Liveable Neighbourhoods Zone 04 - Lower Lansdown

Stage 1/2 Road Safety Audit
Response Report

Project number: 60668625

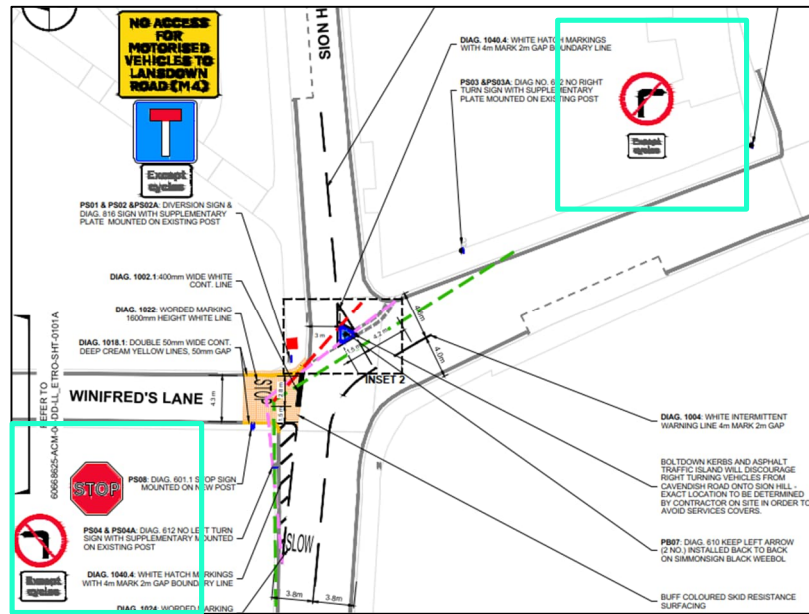
Problem: E1.1	
Drawing Number(s):	60668625-ACM-04-DD-LL_ETRO-SHT-0101B.
Location:	Cavendish Road and Sion Hill.
Summary:	Unclear signage on approach to Winifred's Lane / Sion Hill (east) junction from Cavendish Road and Sion Hill may result in drivers carrying out unsuitable manoeuvres, resulting in graze type or head on collisions with other road users.

The proposals prohibit motorists using Winifred's Lane as a through road, as well as performing right and left turning movements onto Sion Hill (east) from Cavendish Road to Lansdown Road to try and encourage drivers to utilise more appropriate roads. However, the proposed signage on the Cavendish Road northbound and Sion Hill eastbound approaches is unclear.

Northbound motorists approaching the Sion Hill (east) junction from Cavendish Road are informed there is no right turn except for cyclists. Similarly, eastbound motorists approaching the Sion Hill (east) junction from Sion Hill are informed that they are prohibited from turning left except for cyclists. It is unclear from both signs whether these prohibited movements are for Winifred's Lane or Sion Hill (east) due to the close proximity of the two roads.

The Audit Team is concerned that if the information presented on the signs is not clear, motorists may carry out unforeseen turning manoeuvres onto Sion Hill (east) which may lead to graze type or head on collisions with another vehicle on Sion Hill (east). Additionally, unexpected U-turn manoeuvres may be experienced if northbound motorists wish to access Sion Hill (east) without undertaking prohibited movements as the no left turn sign appears to be for Winifred's Lane. This is further exacerbated by the width of the Sion Hill (east) junction access which is proposed as 3m and is potentially wide enough to accommodate vehicle movements.

It is recommended that the prohibited movement signage and its location is reviewed, and that the information presented provides a clear instruction of which roads the prohibited movement is associated with.

Disagree with the recommendation.

The banned left turn movement applies to Winifred's Lane, while the banned right turn movement applies to Sion Hill East. Sion Hill East remains accessible to traffic as straight-ahead movement from Sion Hill (west). The configuration of the signs is such that the banned

turns apply to the first side road in each direction of travel, thus reducing the risk of confusion in the drivers. Given this is an experimental scheme this will be monitored from implementation.

- (i) vehicles travelling eastbound from Sion Hill (West) towards Winifred's Lane will view the banned left turn movement sign.
- (ii) vehicles travelling northbound on Cavendish Road towards Sion Hill (East) will view the banned right turn movement sign.

The Overseeing Organisation therefore agrees with the Designer Organisation response.

No changes are required to the signage.

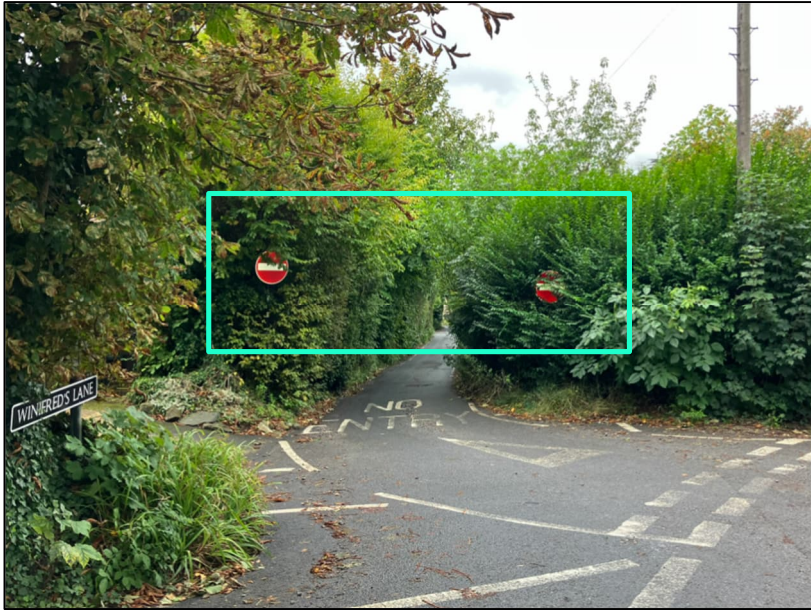
Problem: E1.2	
Drawing Number(s):	60668625-ACM-04-DD-LL_ETRO-SHT-0101B.
Location:	Sion Hill.
Summary:	Proposed signage may be obstructed by existing vegetation, resulting in motorists undertaking prohibited manoeuvres and causing head on or graze type collisions with other road users.
Description:

<p>The proposals mount a prohibited turning sign onto an existing post on Sion Hill; however, during the site visit the Audit Team observed the existing sign to be obstructed by vegetation. If the overhanging vegetation is not cut back and maintained, once the proposed signage is in place, motorists approaching Winifred's Lane from Sion Hill may be unaware of the prohibited vehicular movements along Winifred's Lane due to the obstructed visibility to the sign. This may result in motorists turning left on to Winifred's Lane and causing a head on or graze type collision with other road users.</p>	
Recommendation:	
It is recommended that a maintenance plan is put in place and the vegetation is cut back and maintained regularly.	
Designer Organisation Response:	
<p>Agree with the recommendation</p> <p>Regular maintenance will be undertaken to remove overgrown vegetation for the duration of the experimental order.</p>

Overseeing Organisation Response:	
The Overseeing Organisation agrees with the Designer Organisation response.	
Agreed RSA Action:	
That the Liveable Neighbourhoods CRSTS Project Manager will put in place a maintenance plan to remove overgrown vegetation for the duration of the experimental order.

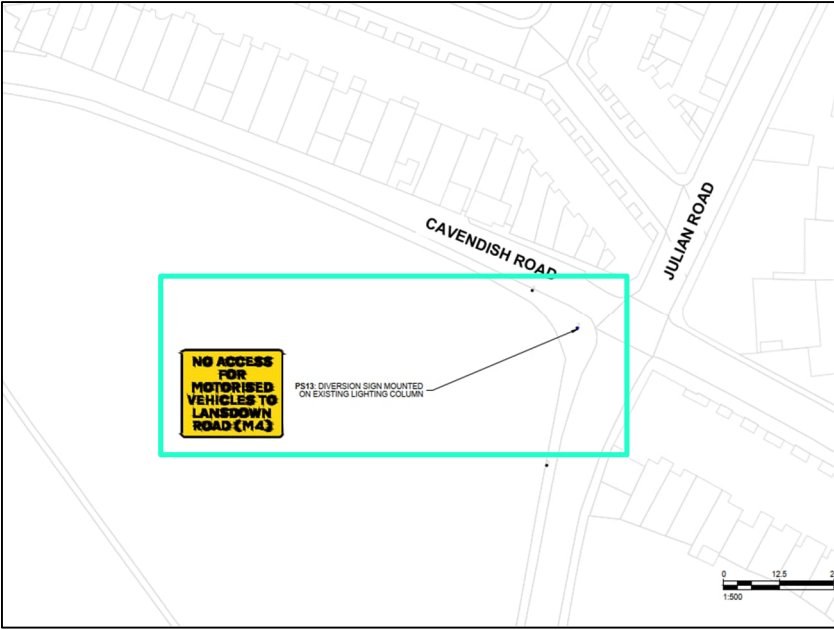
Problem: E1.3	
Drawing Number(s):	60668625-ACM-04-DD-LL_ETRO-SHT-0101A.
Location:	Northern end of Winifred's Lane (junction with Sion Road and Hermitage Road).
Summary:	Proposed signage may be obstructed by existing vegetation, resulting in drivers undertaking prohibited manoeuvres and causing head on or graze type collisions with other road users.
Description:

<p>The proposals outline the use of No Entry signage with yellow backing boards, mounted onto the existing posts at the northern end of Winifred's Lane (junction with Sion Road and Hermitage Road); however, during the site visit the Audit Team observed substantially overgrown vegetation is masking the existing No Entry signage.</p> <p>The Audit Team is concerned that if the existing overgrown vegetation is not maintained, once the proposed signage is in place, drivers approaching Winifred's Lane from Sion Road may be unaware of the prohibited vehicle movements along Winifred's Lane due to the obstructed visibility to the sign. This may result in drivers turning on to Winifred's Lane, increasing the likelihood of a head on or graze type collision with other road users.</p>	
Recommendation:	
It is recommended that a maintenance plan is put in place and the vegetation is cut back and maintained regularly.

Designer Organisation Response:	
<p>Agree with the recommendation</p> <p>Regular maintenance will be undertaken to remove overgrown vegetation for the duration of the experimental order.</p>	
Overseeing Organisation Response:	
The Overseeing Organisation agrees with the Designer Organisation response.	
Agreed RSA Action:	
That the CRSTS Liveable Neighbourhoods Project Manager will put in place a maintenance plan to remove overgrown vegetation for the duration of the experimental order.
